Harmony Education Foundation Replat "A"

City Plan Commission — April 9, 2026 **Revised**

CASE NUMBER/TYPE:	SUSU25-00108 – Resubdivision Combination
CASE MANAGER:	Alonso Hernandez, (915) 212-1585, HernandezJA5@elpasotexas.gov
PROPERTY OWNER:	Harmony Public Schools
REPRESENTATIVE:	CEA Group
LOCATION:	North of Sun Valley Dr. and West of Dyer St. (District 4)
PROPERTY AREA:	1.60 acres
VESTED RIGHTS STATUS:	Not Vested
PARK FEES:	Not Required
EXCEPTIONS/MODIFICATIONS:	Yes, see the following section
ZONING DISTRICT(S):	A-3 (Apartment)

Figure A: Proposed plat with surrounding area

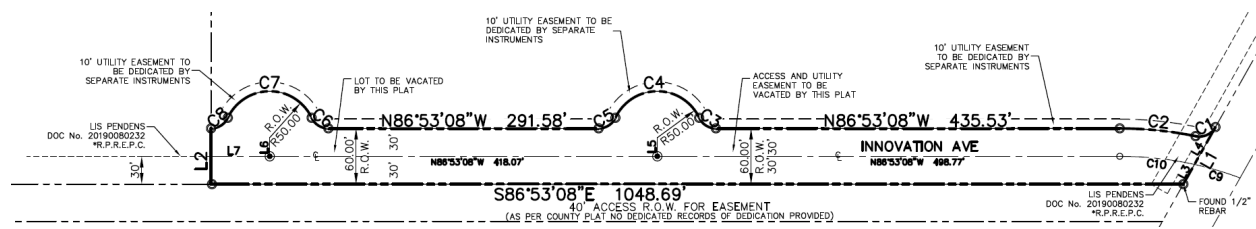
1. To allow the cul-de-sac street to exceed the maximum length of 300 feet.

EXCEPTIONS, MODIFICATIONS, OR WAIVER REQUESTS: The applicant is requesting (1) exception request pursuant to El Paso City Code Section 19.48 – (Petition for Waivers or Exceptions) of the current code involving the El Paso Street Design Manual Section 6.1.4 – Maximum Length of a Cul-De-Sac Street of El Paso Street Design Manual. The exception includes the following:

- To allow the cul-de-sac street to exceed the maximum length of 300 feet.

EVALUATION OF EXCEPTION REQUEST: The applicant meets criteria under 19.48.030 – Criteria for approval, which state that granting the waiver or exception will not be detrimental to the public health, safety, or welfare, or injurious to other property within the area; that granting the waiver or exception will not have the effect of preventing the orderly use and enjoyment of other land within the area in accordance with the provisions of this title, or adversely affect the rights of owners or residents of surrounding property; or that the request for a waiver or exception is not based exclusively on the applicant’s desire for increased financial gain from the property, or to reduce an existing financial hardship. Per Chapter 6.1.4 Maximum Length of a Cul-De-Sac Street of the Street Design Manual, Additional modifications may be required by the City Plan Commission upon recommendation by the fire marshal’s office including intermediate turnarounds (eyebrows) to accommodate emergency vehicles being provided at a maximum distance of six hundred feet or whichever is less. Fire Department does not object to this request.

SUMMARY OF RECOMMENDATION: Staff recommends **APPROVAL** of Harmony Education Foundation Replat "A" on a Resubdivision Combination basis and **APPROVAL** of the exception requests. Related to this application, the applicant is requesting the following exceptions from the City Plan Commission:
